Application for Variation of an Environmental Permit

C1. Name of the Current Environmental Permit Holder :  
Drainage Services Department  
C2. Application No. of the Current Environmental Permit : AEP-517/2016  
C3. The Current Environmental Permit was Issued in : month / year  
02 | 2017

**Environmental Review Report -  
Change of Horizontal Directional Drilling Method**

Agreement No. CE 63/2012 (DS)  
Expansion of Sha Tau Kok Sewage Treatment Works, Phase 1 –  
Investigation, Design and Construction

Figure 2.1 Proposed Submarine Outfall and Diffuser (Extracted from the EIA Report)

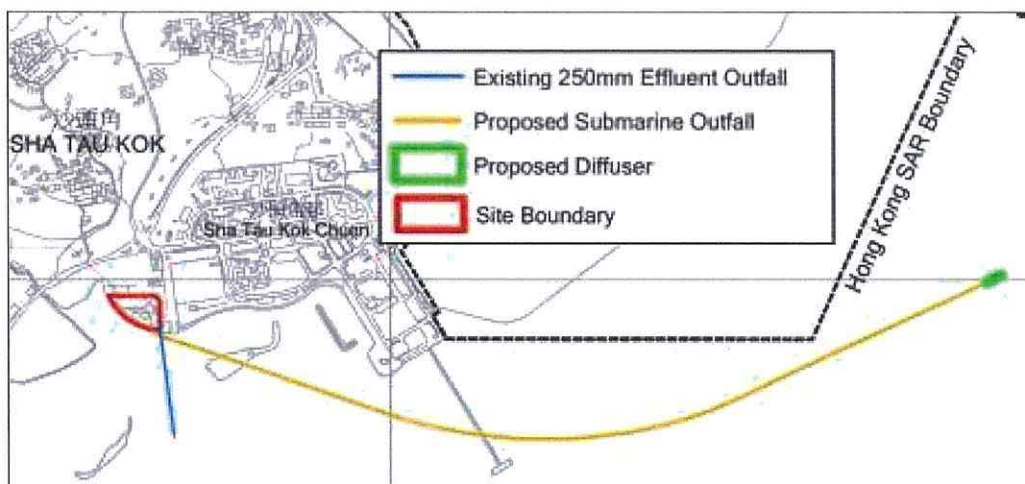
The proposed submarine outfall of the Project will be installed by trenchless method (i.e. Horizontal Directional Drilling, HDD). The methods and sequences of the HDD works proposed in the EIA Report are described as follows.

Drilling of pilot hole would proceed from the land side at the STKSTW site and approach to the outfall diffuser site (one directional drilling). Construction of marine cofferdam at the diffuser site would follow. The cofferdam would be constructed using interlocking sheetpiles to provide a water-tight environment at the diffuser site.

Reaming of drilled hole and submarine pipeline installation would then proceed. Subsequently, sediment removal, installation of precast diffuser structure and backfilling would be carried out within the cofferdam. The cofferdam would be removed after completion of all the outfall construction works. The EIA Report assumed that the cofferdam would be erected at the diffuser site for over 2 years.

The proposed change would involve proceeding the HDD works from both land side and sea side at the same time (two directional drilling) until they meet and connect to each other within the bedrock. The HDD works from the land side would commence at the STKSTW site as assumed in the EIA Report. The HDD works from the sea side would start at the diffuser site. There would be no changes to the outfall alignment and location of the diffuser site. As HDD would be a trenchless method, the key concern would be associated with the drilling works from the sea side, which would disturb the seabed and potentially cause a release of fines.

Figure 2.3 Cross-sectional View and Plan View of Steel Casing and Scaffold

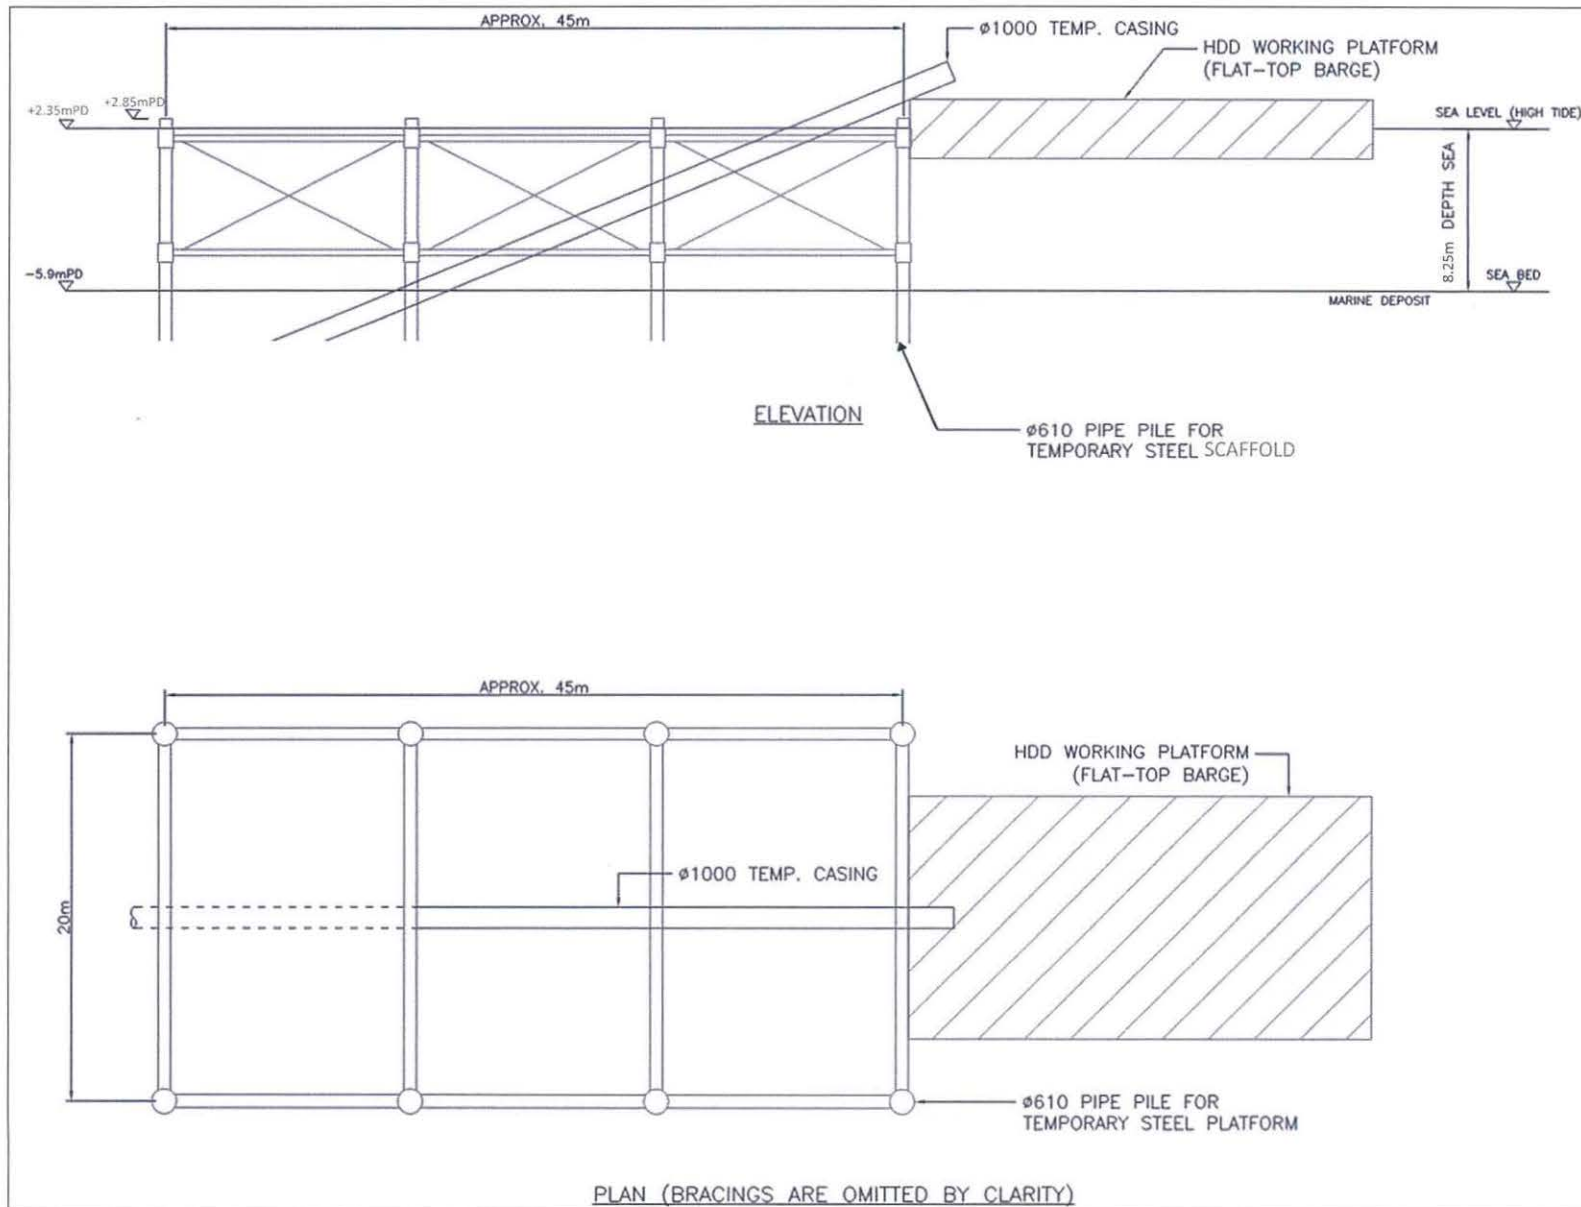
- (i) Construct a temporary steel scaffold at the diffuser site to facilitate the HDD works;
- (ii) Install a temporary steel casing through marine deposit and alluvium to the bedrock (the other end of the casing would be above the seawater level to provide a confined environment for the subsequent drilling and pipeline installation works);
- (iii) Drill and ream HDD hole and then install submarine pipeline through the temporary steel casing into the seabed;
- (iv) Remove temporary steel casing at the diffuser site;
- (v) Remove temporary steel scaffold at the diffuser site; and
- (vi) Finish HDD works.

The water depth at the diffuser site would be about 5.95 to 8.25m m. The level of seabed, alluvium, and bedrock would be about -5.9mPD, -10.4mPD and -49.5mPD respectively. The temporary steel scaffold would be supported by 8 nos. of pipe piles and each pile would have a diameter of 0.61 m. The length of each pipe pile would be about 21 m and would be inserted perpendicular to the seabed level. Silt curtain will be deployed to surround the pipe pile insertion and removal works to minimize the environmental impact. The steel casing would have a maximum diameter of 1 m and a total length of about 70m. The steel casing would be inserted into the seabed at an inclination angle of 22.5° from the seabed. The temporary steel scaffold would consist of at least two nos. of steel bracket in the form of "U-shape" to support the steel casing and to secure the casing of any laterally movement during installation as illustrated in **Figure 2.2**. The cross-sectional view and plan view of the steel casing and scaffold is shown in **Figure 2.3**.

Figure 2.4 Cross-sectional View and Plan View of Cofferdam

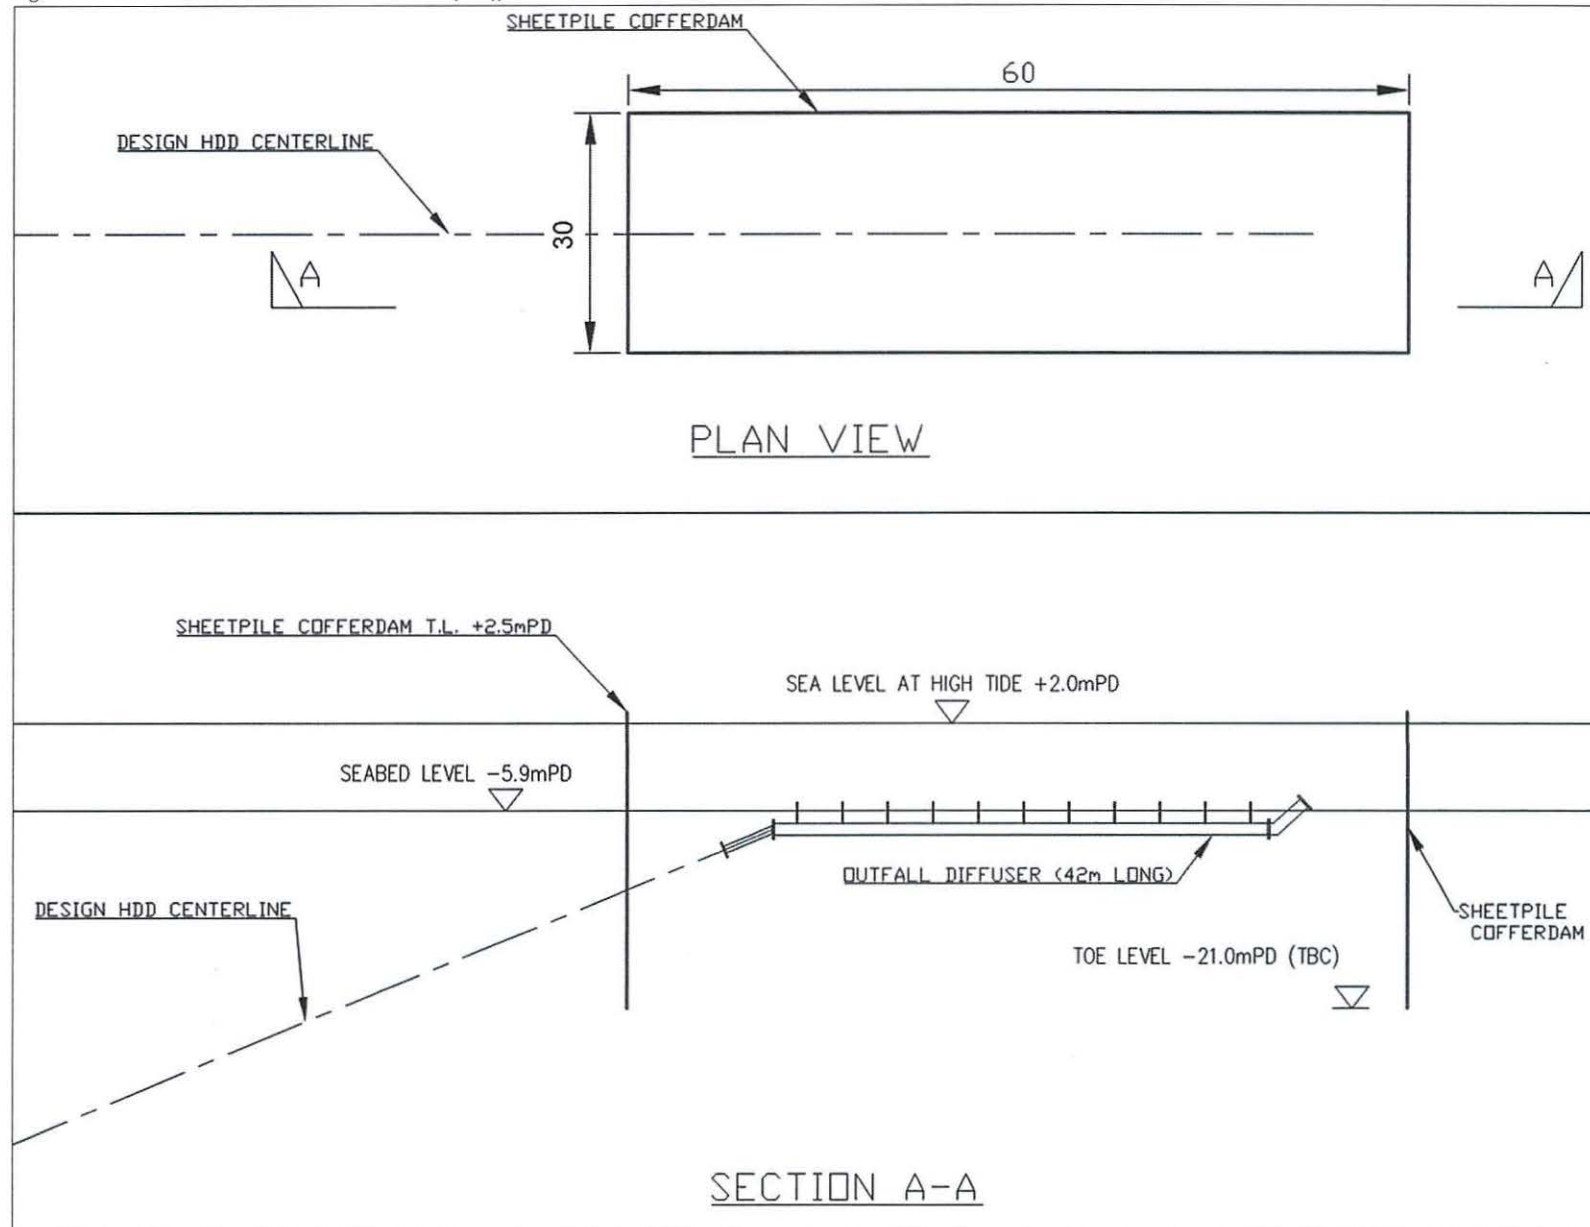
No additional working pit and dredging work are required by using the two-way

HDD method. After completion of the HDD works, a marine cofferdam as assumed in the EIA would be installed. Sediment removal and diffuser installation works would then proceed within the cofferdam. The construction methods and locations for the cofferdam installation, sediment removal and diffuser installation works would remain unchanged. Sediment removal and backfilling would be confined within the cofferdam as assumed in the EIA Report. The cross-sectional view and plan view of the cofferdam structure is shown in **Figure 2.4**.

Figure 3.2 Comparison of Construction Sequence for Alternative HDD Methods

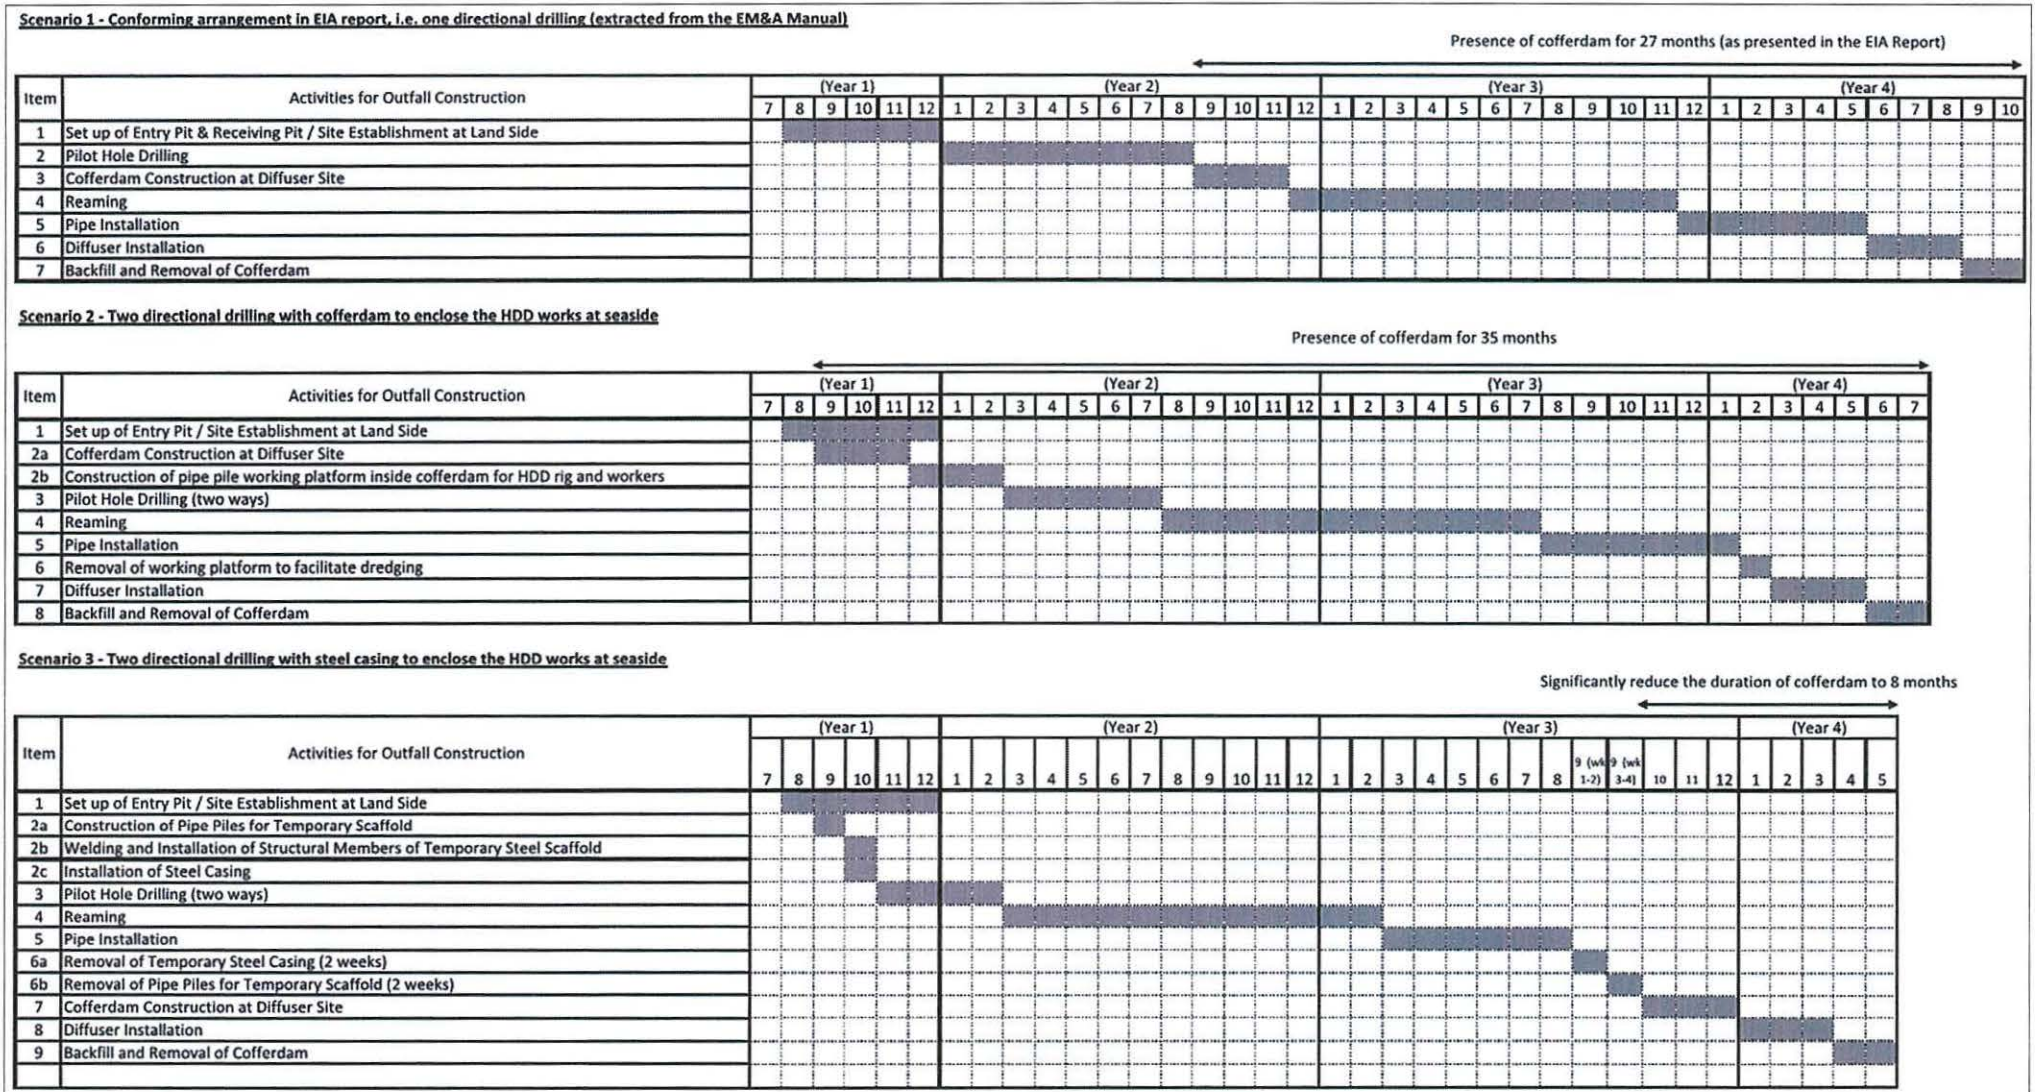
The duration of temporary loss of fisheries habitat and fishing ground of 1 ha. <sup>(3)</sup> would be increased from approximately 27 months to approximately 35 months as illustrated in Figure 3.2 below.

The duration of temporary loss of subtidal soft bottom habitats of 0.18 ha. would be increased from approximately 27 months to approximately 35 months as illustrated in Figure 3.2 below.

The duration of temporary loss of fisheries habitat and fishing ground would be changed from approximately 35 months under Scenario 2 to approximately 33 months under Scenario 3 as illustrated in Figure 3.2. Under Scenario 2, cofferdam in the form of interlocking sheetpiles would be used to enclose the HDD works and extra time would be required for maintenance of the cofferdam to secure its watertightness as the pilot drilling works would be suspended intermittently to maintain the cofferdam under a drained condition. The maintenance would disrupt and prolong the pilot hole drilling operation. In this respect, the duration of pilot drilling under Scenario 2 would be longer than the scenario of using a steel casing to enclose the HDD works. Hence, the overall duration of marine works under Scenario 3 would be less than that under Scenario 2.

Figure 4.3 Typical Arrangement of Pipe Piling

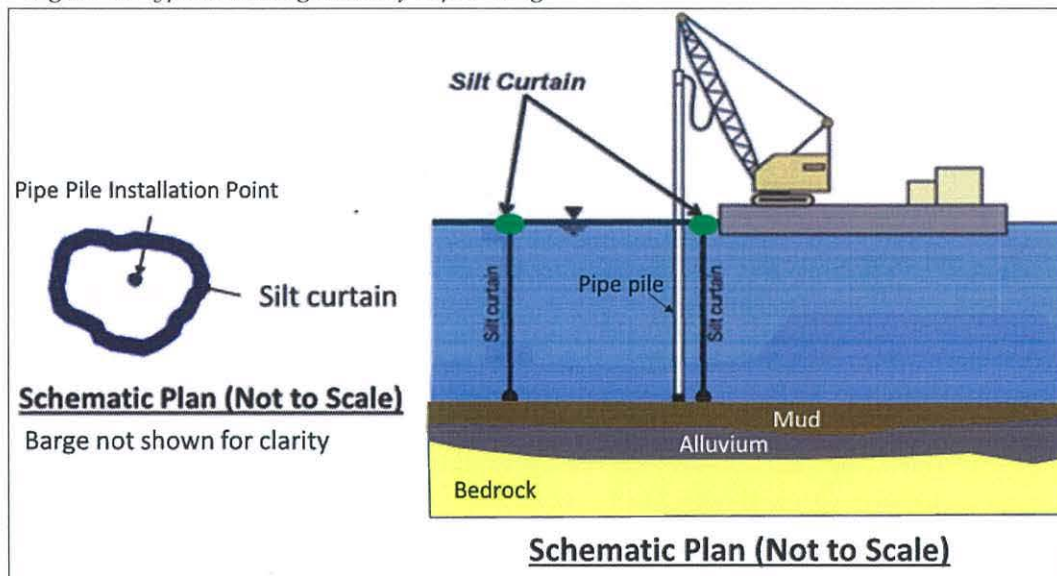
The mitigated or effective sediment loss rate from the pipe piling or pile removal work after implementation of the silt curtains would be reduced to 0.0022 kg / sec (or 0.0087 kg / sec ÷ 4). This is 2 times lower than the sediment loss rate of 0.0044 kg / sec for the sheetpiling work as assessed in the EIA Report. Water

quality impacts associated with the sheetpiling work were predicted in the EIA Report to be minimal and acceptable (as discussed in Section 4.6). Full compliance with the water quality objectives was predicted in the EIA Report. The proposed insertion and removal of pipe pile would not be undertaken concurrently with other marine works of this Project such as the cofferdam installation / removal works. Hence, the water quality impact of the sheetpiling works as assessed in the EIA Report would remain a worst-case condition. No unacceptable water quality impact would arise from the construction of the temporary scaffold. Full compliance with the water quality objectives would be achieved during the pipe pile insertion and removal. The typical arrangement of the piling work is illustrated in Figure 4.3.

Figure 4.4 Inclination of Steel Casing

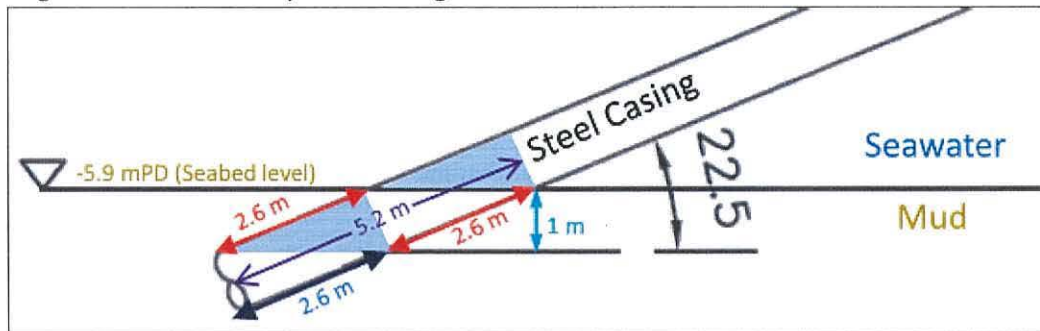
Following the EIA assumption, only the first 1 meter of sediment at the surface of the seabed would be potentially released into the water during the insertion or removal of the steel casing. After the initial insertion or removal action, these surface sediments would have been displaced or released by the vibratory action and no more sediment loss would occur from the remaining insertion or removal process. The EIA assumed that sediment below 1 m of the seabed level would not be brought up to the surface by the vibratory action. The steel casing would be inserted or removed at an inclination angle of 22.5° as shown in Figure 4.4.

Due to the inclination, the steel casing would need to be inserted or removed for a total length of about 5.2 m before it can completely displace the top 1 meter of sediment as shown in Figure 4.4. It would take about 5.2 hours to complete this initial process (or on average 1 hour per 1 meter of steel casing insertion or removal). Based on the same principles adopted in the EIA Report, the volume of sediment to be disturbed would be the same as the volume of the sediment to be displaced by the steel casing structure within the surface sediment layer. The sediment loss rate for steel casing insertion or removal would be about 0.0035 kg /sec (see calculations below):

Figure 4.5 Typical Arrangement of Steel Casing

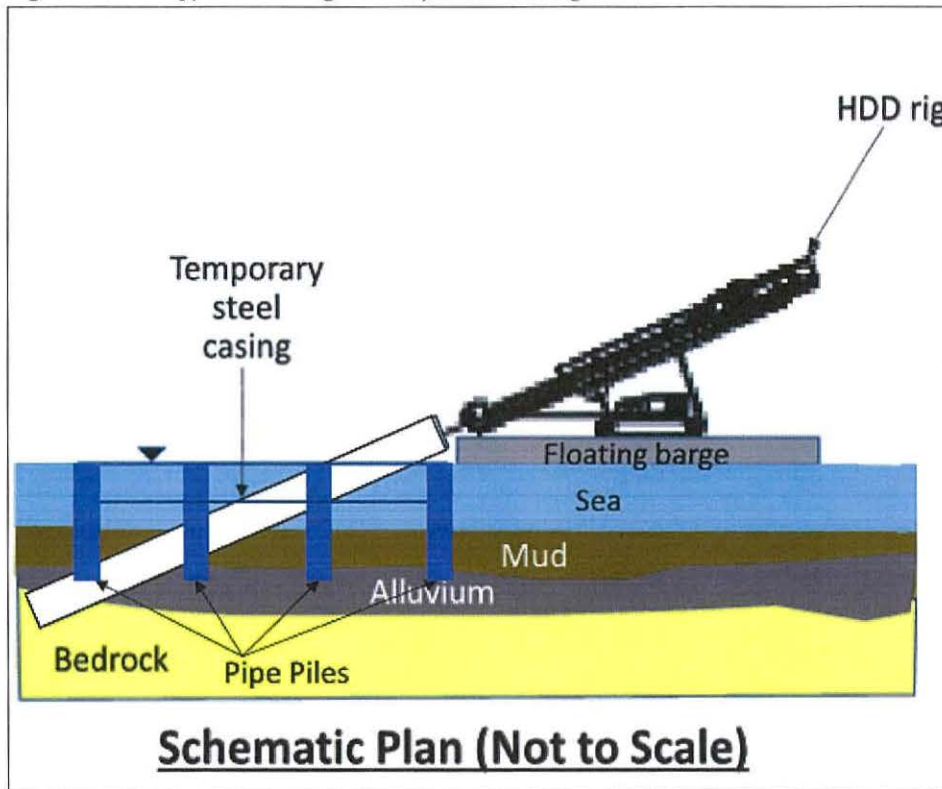
A steel casing is proposed under the revised design to enclose the HDD works from the sea side (refer to Section 2.2). The programme for inserting and removal of the steel casing would be about 1 month and 2 weeks respectively. The installation of steel casing would be slower than the removal of the steel casing. For the purpose of sediment loss rate calculation (as shown in the later paragraphs), it is assumed that the rate of steel casing insertion would be the same as the rate of steel casing removal. In actuality, both the insertion and removal rate would not be faster than that assumed in the sediment loss rate calculations below.

The typical set up of the drill rig and steel casing is illustrated in Figure 4.5 below.
